SAFETY EVALUATION BY THE OFFICE OF NUCLEAR REACTOR REGULATION

SUPPORTING AMENDMENT NO. 86 TO PROVISIONAL OPERATING LICENSE NO. DPR-13

SAN ONOFRE NUCLEAR GENERATING STATION, UNIT NO. 1

DOCKET NO. 50-206

Figure 1 Salt water cooling system.

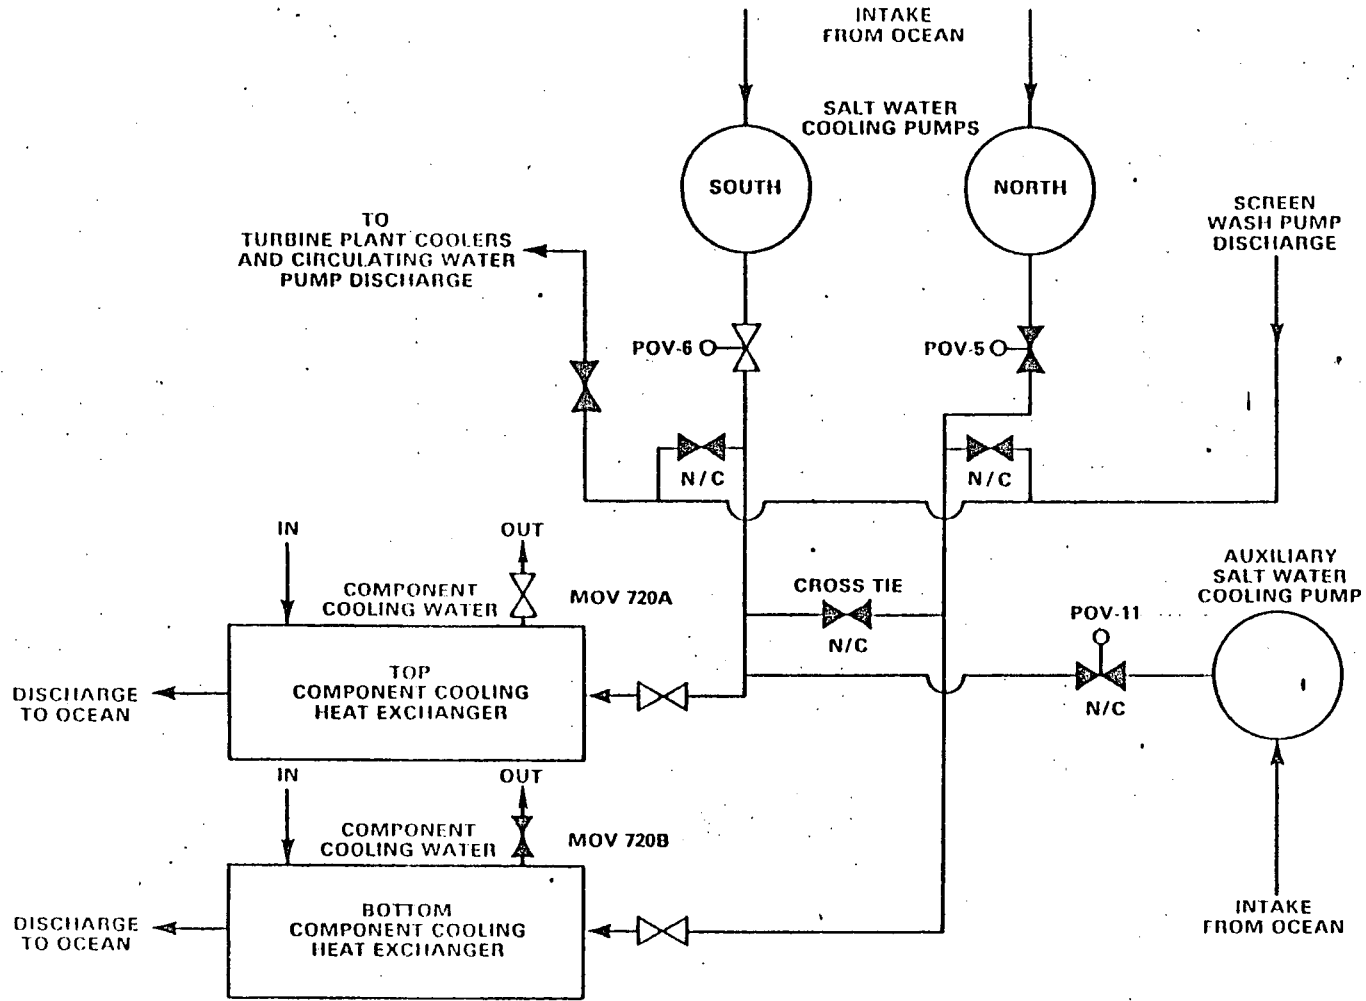
The ultimate heat sink requirements for San Onofre Unit 1 are satisfied by the SWC system. The existing Technical Specifications require that the reactor not be made or maintained critical unless two SWC pumps (North and South) or one SWC pump (North or South) and the Auxiliary Salt Water Cooling (ASWC) pump are operable. The two SWC pumps are located in a sealed, common pit, which is protected against design basis flooding and tsunami concerns. Also located in this pit are the screen wash pumps. The ASWC pump is located in a separate pit. Figure 1 depicts the salt water cooling system configuration.

In a Safety Evaluation (SE) dated October 28, 1983 (Ref. 3), the staff rejected the licensee's request to delete the ASWC pump from the Technical Specifications. The staff argued that by eliminating the option of including the ASWC pump in the SWC system and not placing it as a backup or standby unit, the residual heat removal (RHR) cooling system will depend only on the two SWC pumps which have the following design characteristics which have shown the system to be less reliable than desired.

- (1) Both pumps are located in a common pit (circulating water pump (CWP) pit) and, thus, are subjected to common mode failure by flooding. On May 13, 1982 both pumps were made inoperable due to flooding.
- (2) During normal operation either one of the two pumps is capable of performing its function. However, when the RHR system is first placed in service during plant shutdown, both component cooling water (CCW) heat exchangers and hence both the SWC pumps are relied upon (Ref. 5).
- (3) The reliability of the SWC system has been poor with four system failures within 3 years.

The ASWC pump does not have seismic qualification but does contribute significantly to the overall system reliability. In addition, the two screen wash pumps were used as backup pumps during some of the SWC system failures. The staff further pointed out that the licensee is reviewing the SWC system for the single failure criterion under SEP Topic IX-3. References 5 and 6 have considered the ASWC pump as a backup to the SWC pumps. The ASWC pump can be used as backup if the SWC pumps are inoperable or insufficient as previously indicated. The ASWC pump is suitable for the backup function for the following reasons.

- (1) It is located in a separate pit, remote from CWP pit.
- (2) Its motor is supplied from a safety-related 480-volt load center and, as such is electrically as qualified as the SWC pumps.
- (3) Its capacity is the same as that of a SWC pump (4600 gpm).
- (4) The licensee intends to enhance the pumps reliability and dependability by improving the vacuum priming system, installing mechanical seals to minimize air inleakage or provision for gland sealing water (Ref. 4).
- (5) The pump is different in design (a horizontal rather than vertical pump) and therefore adds diversity to the SWC system.

The staff concluded that the Technical Specifications should address both the ASWC pump and the screen wash pumps as backup sources of cooling, in addition to the two SWC pumps, to be available during periods when the plant is in Modes 1, 2, 3, and 4.
